Reviewer comments and author responses

Reviewer 1:

Reviewer 2:

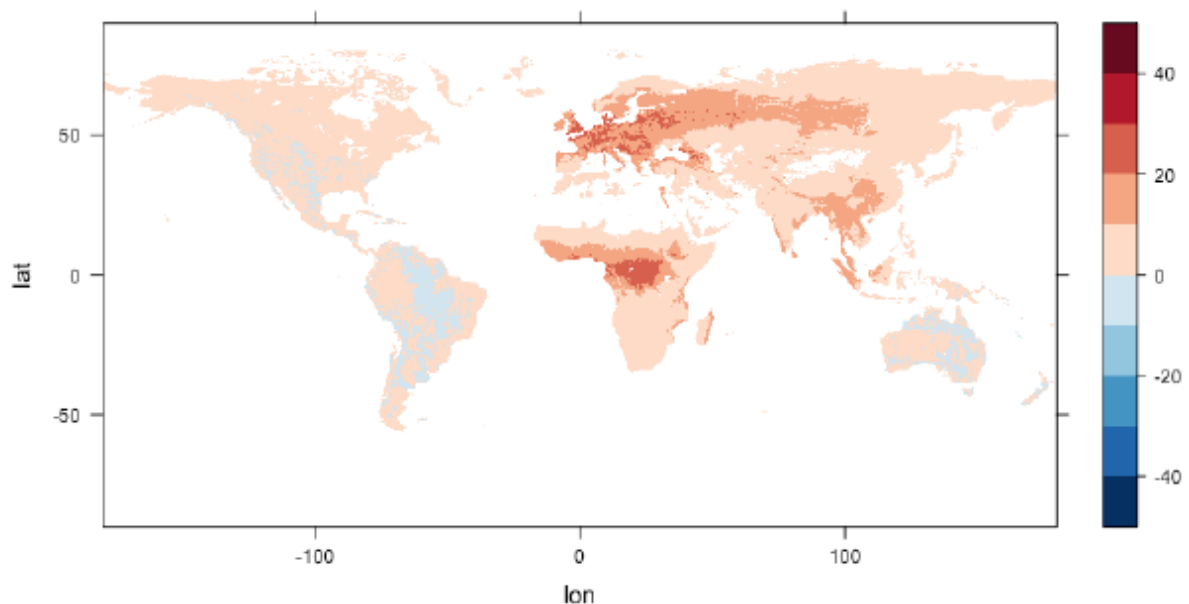
3) Possible data file error. If due to an ingest or plotting error by this reviewer, authors need to verify original file and contents. If confirmed, authors will need to implement a thorough check and validation across all source files. Manuscript not acceptable without one or the other outcome.

Using ncdf4 library in R I opened one of the ADC (average diel cycle) files, extracted a month and hour time slice and plotted it (below). As specified in the netCDF file, scale = 1 and offset = 0, e.g. no scaling or offset. This 4D file: GPP_halfhourly_monthlyADC.upscalingProduct v1.array4D.720.360.2010.nc; with this float variable: GPP_halfhourly_monthlyADC (average diurnal/diel cycle?); at Hour = 20 (roughly 1200 local over North America or, if 20th position in the array rather than 20 UTC, 1000 local over Europe?); and Month = 6 (June). Apologies for the weak plot. I do not claim expertise in R but I use it semi-regularly for data processing and to open and check ESSD data files of various formats. In the plot below, I have obviously preserved correct X (lon) and Y (lat). I would not have expected negative GPP values? Please can the authors check to assure that this result represents an ingest or plotting error by me and not an error in the data files. Negative values suggest that we might have an NEE rather than GPP file? If we do have a file type or data type error, the authors then need to check and verify the full set of files?

The reviewer spotted slightly negative GPP values during nighttime in the provided data products, which are then claimed as possible data file error. We have checked the files and there is no data file error. Also the plot that has been provided by the reviewer is correct. However, the reviewer has explained the issue in more detail in the next comment (Data check) and we give a detailed answer there.

We appreciate the reviewers effort in checking the data files and raising the issue of negative GPP values during nighttime. First of all, the plot is correct and slightly negative GPP values seem to be unreasonable at first glance. The reason for this is that the flux partitioning of NEE into GPP and terrestrial ecosystem respiration (TER) at site level can result in slightly negative values, which is an artifact of the flux partitioning method that we do not have under control. Hence, we already have negative GPP values in the training set of the machine learning model and thus, this model will also produce slightly negative values for similar environmental conditions at global scale.

In other words, consider the observed GPP as a sum of the true GPP and observational noise: $GPP_{obs} = GPP_{true} + noise$. Especially during night, GPP_{true} will be equal to zero but the noise term (depending e.g. on measurement system and device) might lead to negative GPP observations. As indicated earlier, this observational error at site level is inherent in the training set and propagates into the derived data-driven upscaling product.

Please note that the discrete color scale of the map provided by the reviewer is a bit misleading, because the light blue color that dominates in the map spans a large range of 0 to -10. In fact, we have verified that the smallest value in this map is about -1.5 (micro mole per square meter and second).

However, setting the negative values to 0 (either at site level before training or at global scale as post-processing) would generate a bias (just consider a mean value of zero with some random variations as a comparable example). We therefore agreed on keeping negative values but understand that this can cause confusion. We have therefore added a paragraph in the section "Data availability and usage notes" that points to that issue and indicated an optional post-processing step to set negative GPP values to 0 for specific applications.

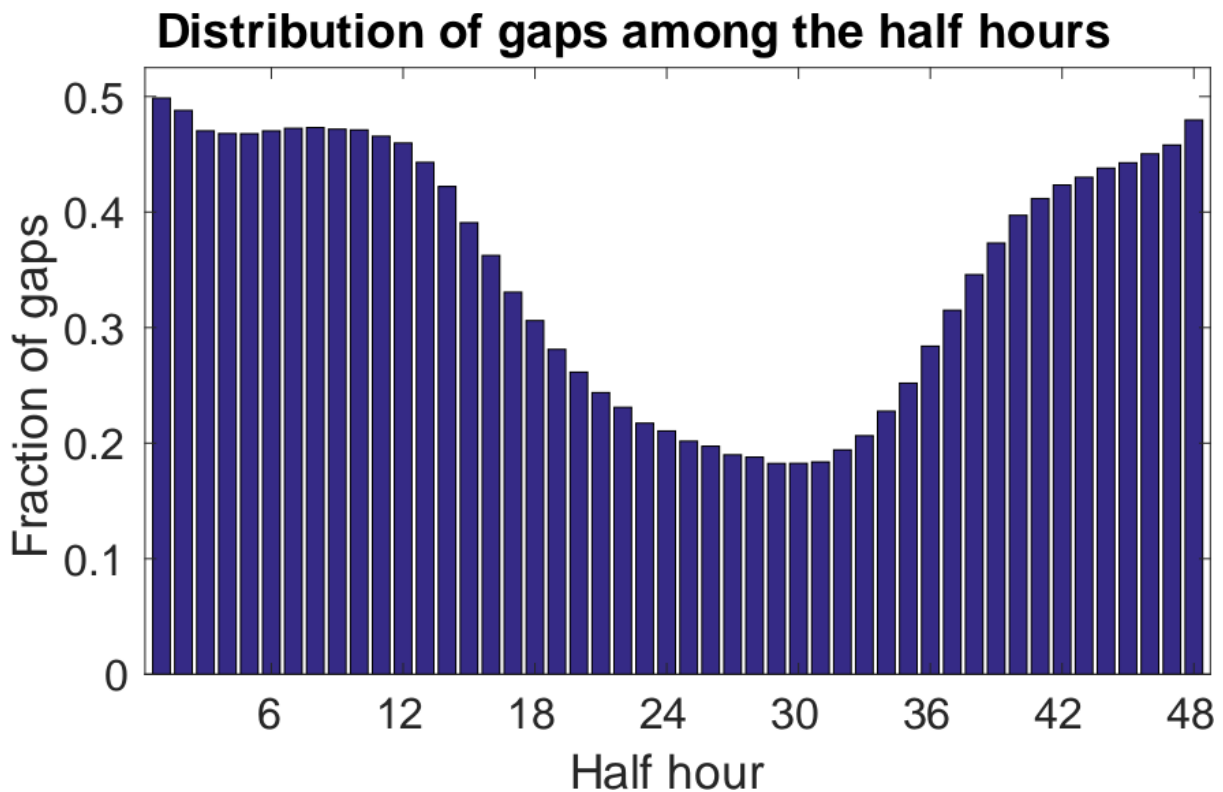
Page 4 line 13: the authors should help us understand the frequency and impact of these gaps? 20% (my best guess) due to instrument failures, power failures, data recording failures? Can the authors assure us of random gaps over the diel operation periods or do the gaps have diurnal or nocturnal dominance? If the authors want to assure on this point, e.g. that they can 'safely' ignore gaps, we need a more information.

We do understand that the reviewer is concerned about the data gaps in the flux measurements. From a machine learning perspective, we can anyway only do the training on the data we have, independent of their distribution in time. Furthermore, we have decided to not include gapfilled data in order to prevent the machine learning model to adapt too much to the gapfilling method. However, we have found

that within all the site-days that we have taken into account, there are roughly 35% gaps and the following figure shows their distribution among the half hours.

One can clearly observe a nighttime dominance of the gaps. For GPP, this is not a big problem, because it is assumed to be zero during night anyhow. Considering NEE, the absolute fluxes are also smaller during night compared to daytime observations. The nighttime dominance of gaps arises from less turbulence during these hours and this is an inherent problem of the measurement devices that we cannot resolve. However, it should be noted that such a biased distribution of gaps does not directly lead to a model bias as it would be the case for example for linear methods. Since we have picked random forests as a nonlinear machine learning technique, our derived models are less biased for imbalanced data because the final estimations in the leaf nodes of the decision trees are made locally in predictor space by considering mean values from samples that fall into the respective leaf node. Hence, they are independent from samples that are far away in predictor space but could potentially have higher or lower density.

In addition, we have also carried out preliminary experiments where we have only used site-days with no gaps, i.e., where all 48 half-hourly values have been available. This has then reduced the overall number of training samples massively and has clearly reduced prediction performance, most likely due to worse generalization abilities because the reduced training data did not capture all environmental conditions sufficiently well. We have included a section in the appendix of the paper that describes these issues of the data gaps and we refer to
